**OHIO TURNPIKE AND
INFRASTRUCTURE COMMISSION**

ADDENDUM NO. 3

**PROJECT NO. 43-17-05
BRIDGE DECK REPAIR AND REHABILITATION
BOSTON MILLS ROAD OVER OHIO TURNPIKE M.P. 178.0,
OLDE EIGHT ROAD OVER OHIO TURNPIKE M.P. 179.5,
NICHOLS ROAD OVER OHIO TURNPIKE M.P. 199.2,
SUMMIT AND PORTAGE COUNTIES, OHIO**

MODIFICATION TO PLAN SHEETS 2, 8, 12, 18, 32, 39 AND 44

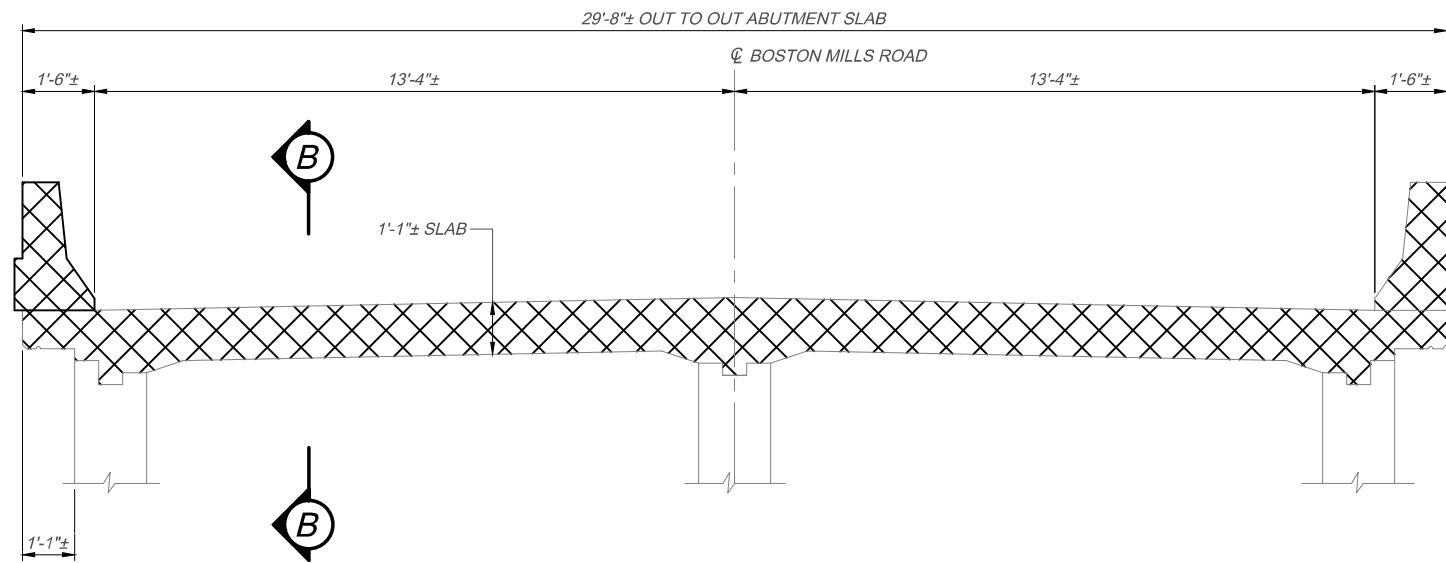
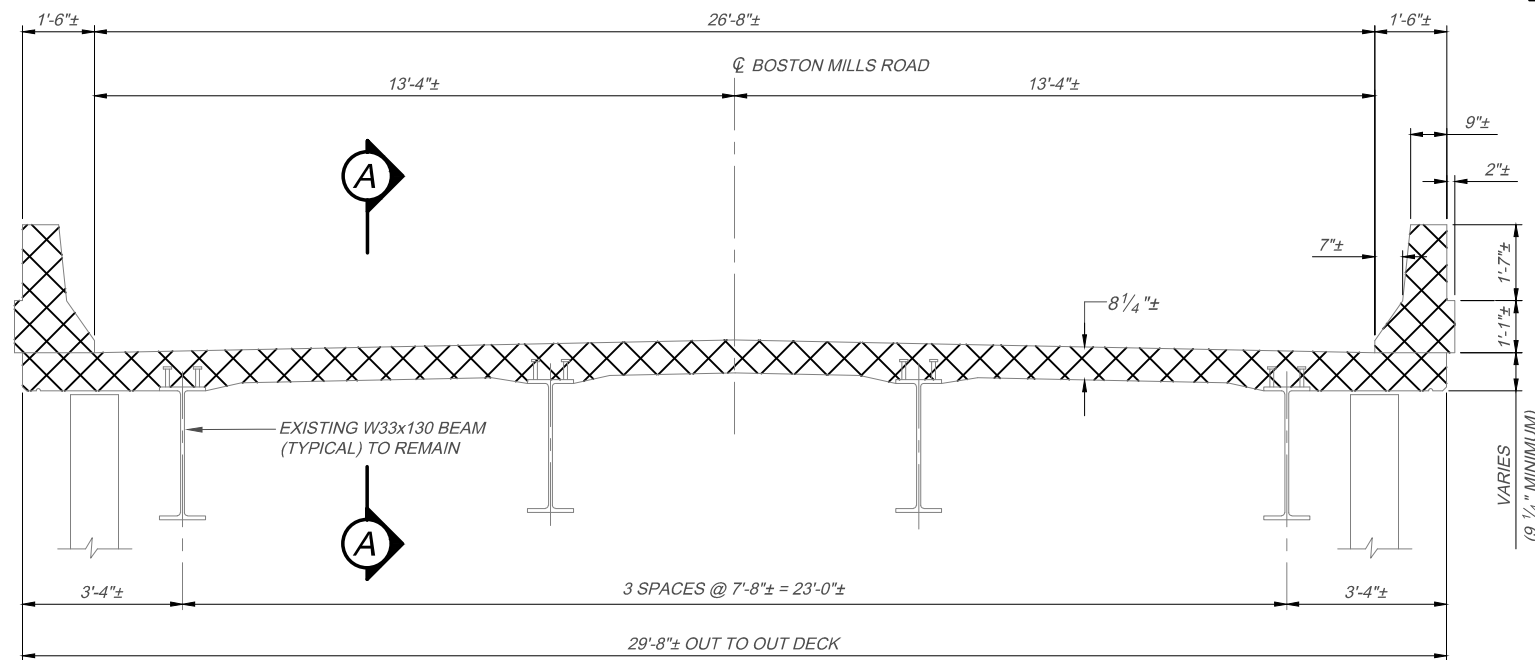
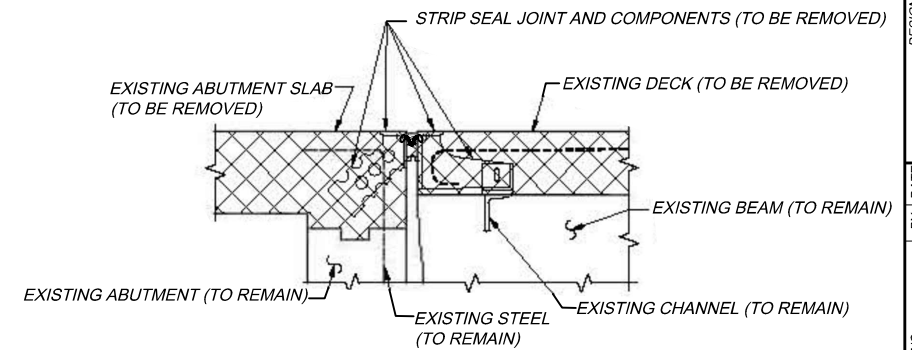
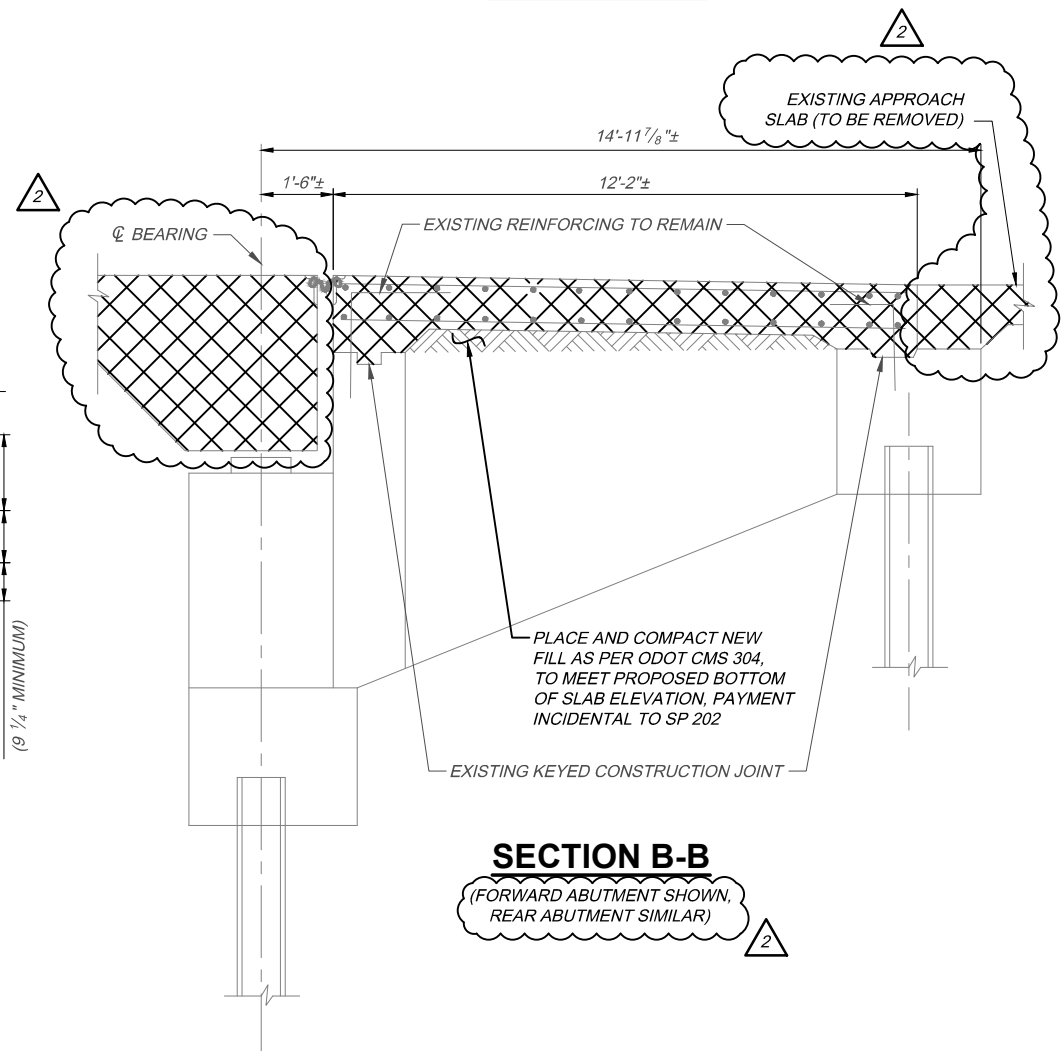
Q#11 The existing bridge sections for Boston Mills (sheet 12/49) and Nichols (sheet 40/49) do not depict existing deck counterweights. The existing bridge plans for Boston Mills shows counterweights while Nichols does not. Please confirm if there are existing counterweights at any of the structures.

A#11 There are existing counterweights at Boston Mills, as indicated on the existing plans and will be replaced at Boston Mills. There are no existing counterweights at Nichols Road, but this project will add the counterweights at Nichols Road.

PROJECT 43-17-05	DESIGNED		CHECKED	NO.	REVISIONS	BY	DATE
	DEB	VFG	JTH	2	ADDENDUM NO. 2	TMR	11/19/17
8 / 15	ABUTMENT SLAB DETAILS		BOSTON MILLS ROAD OVER OHIO TURNPIKE		SUMMIT COUNTY		
18 / 49	M.P. 178.0		OHIO TURNPIKE

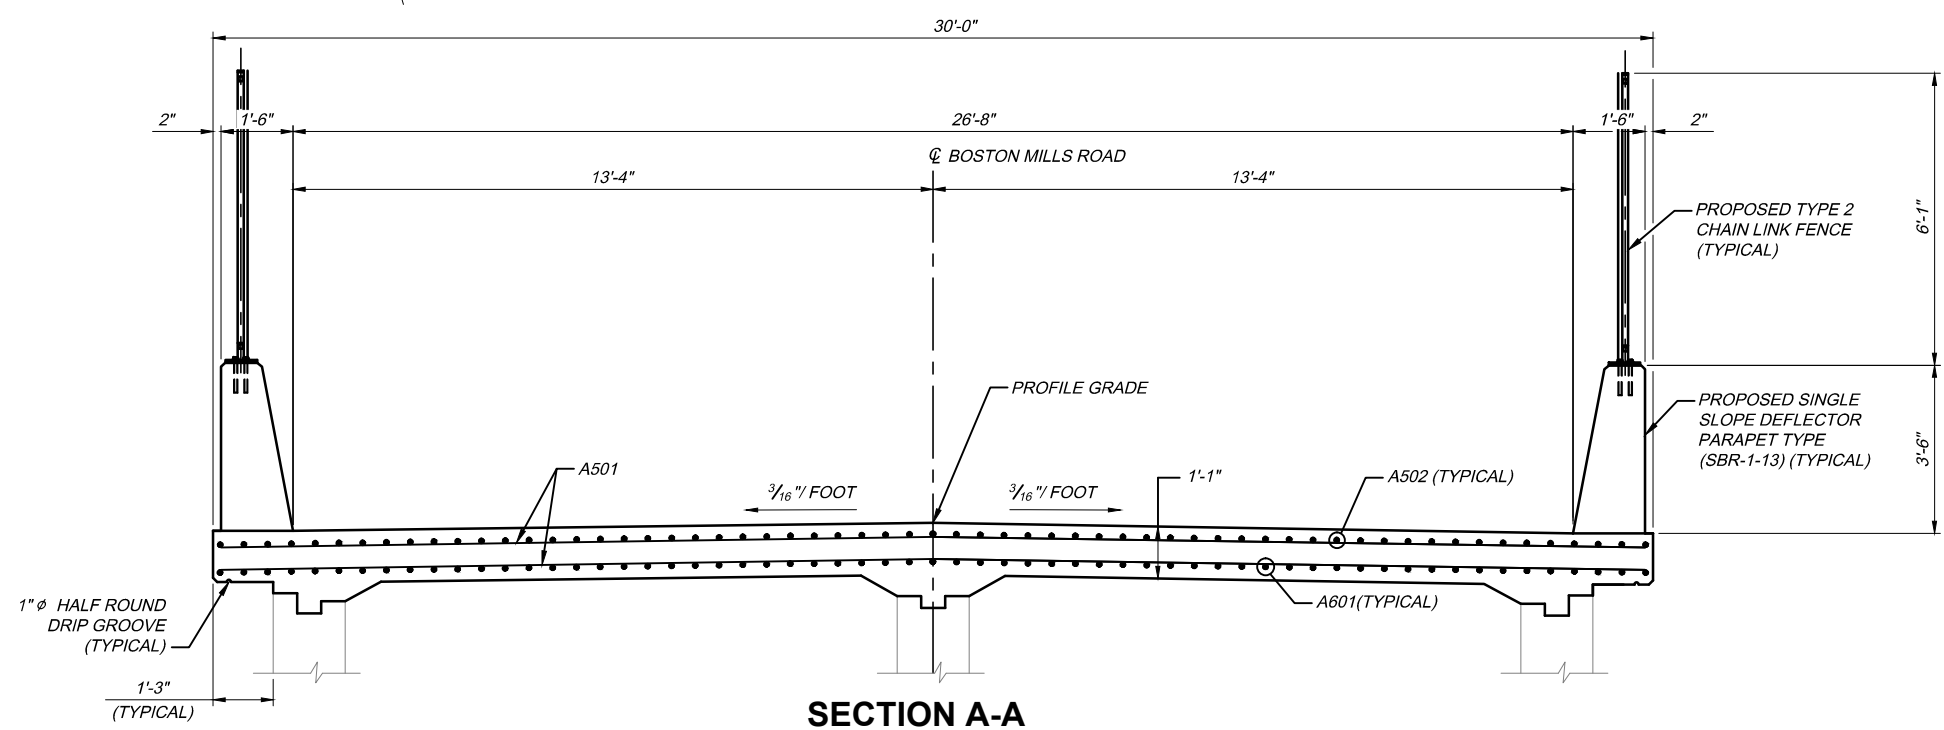
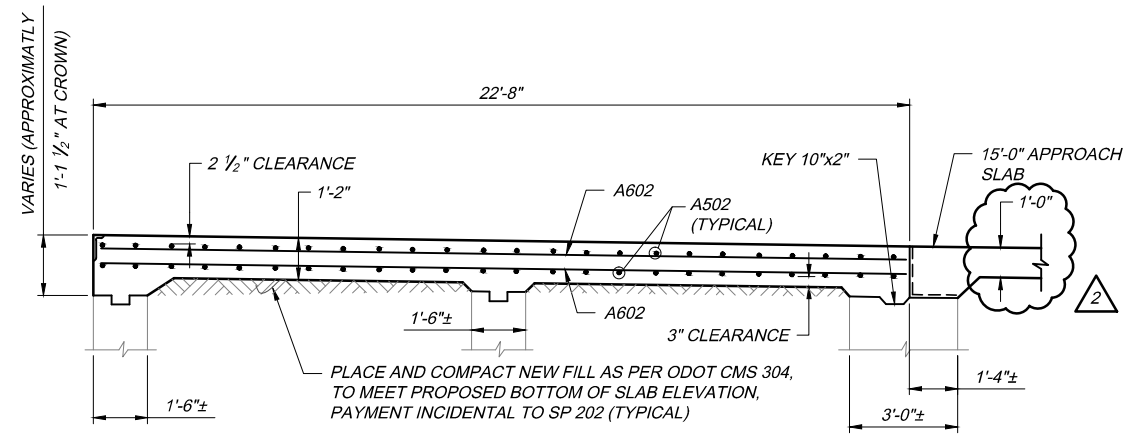
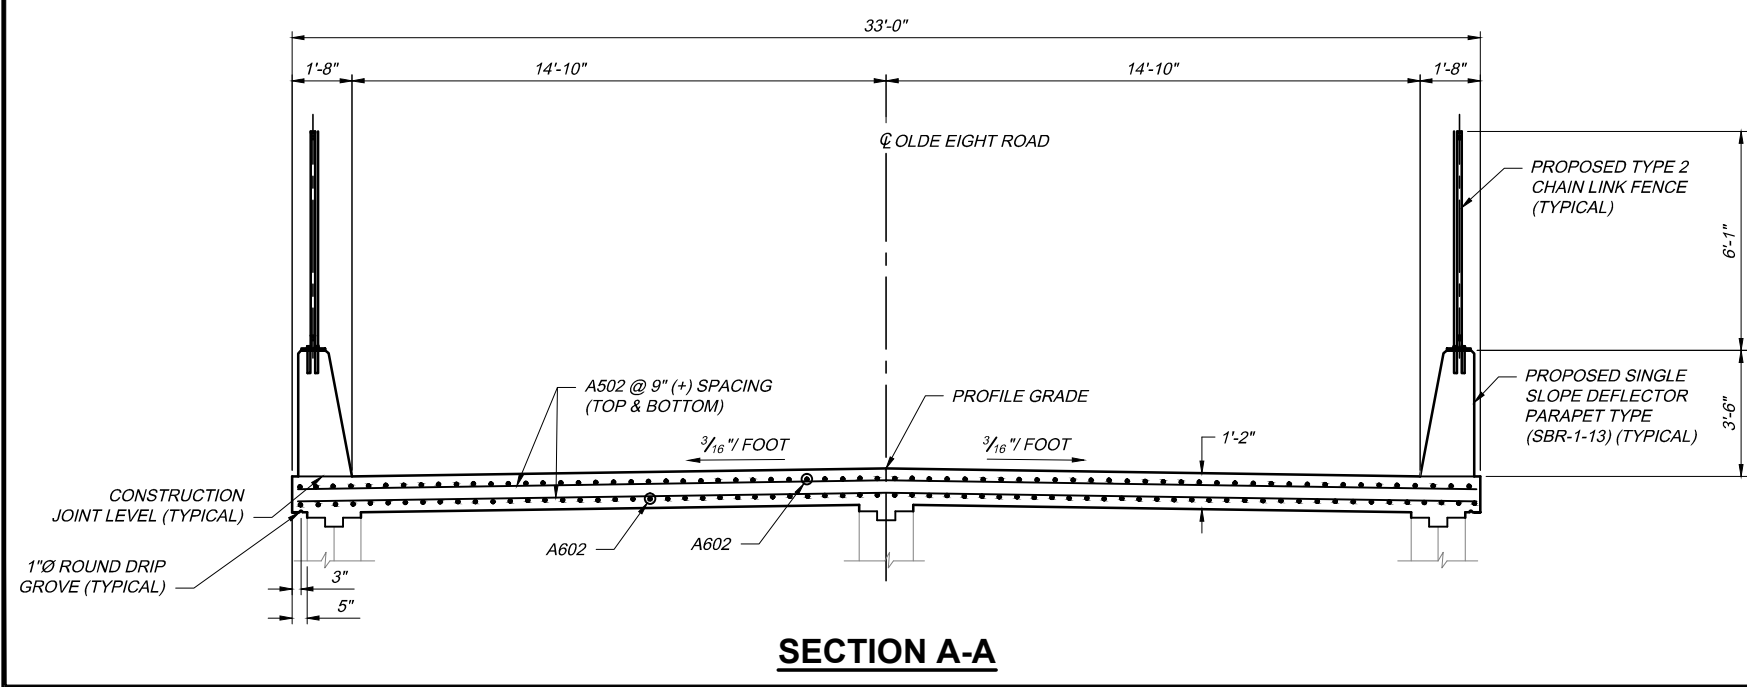
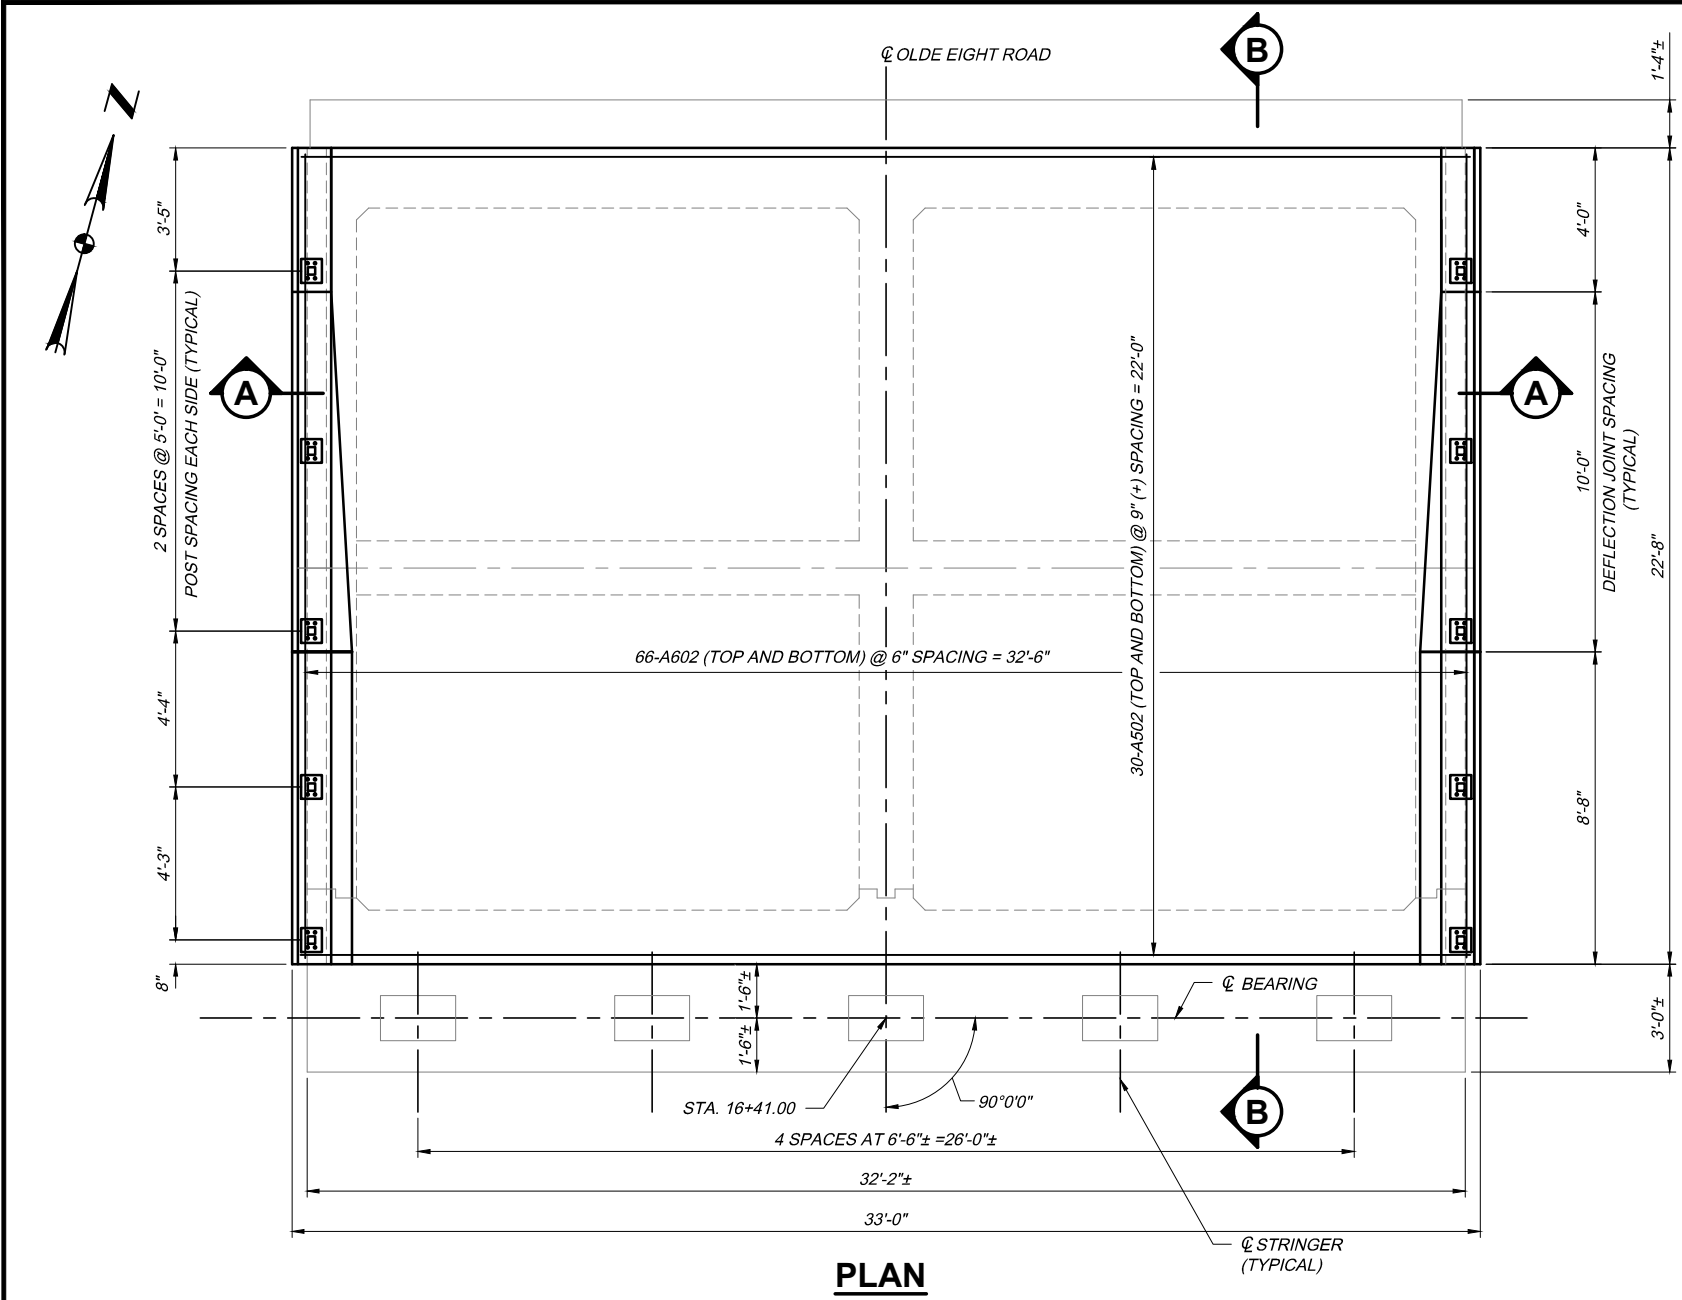
Q#15 The Olde Eight bridge plans indicate removal of the existing approach slab, however the Boston Mills plans do not indicate that the existing slabs are being removed. There is quantity for new slabs on Boston Mills. Please verify that the approach slabs at both locations are being removed and replaced.

A#15 Yes, Plan Sheets 2 and 18 of 49 have been revised to clarify that the Boston Mills Road approach slabs are to be removed and replaced.
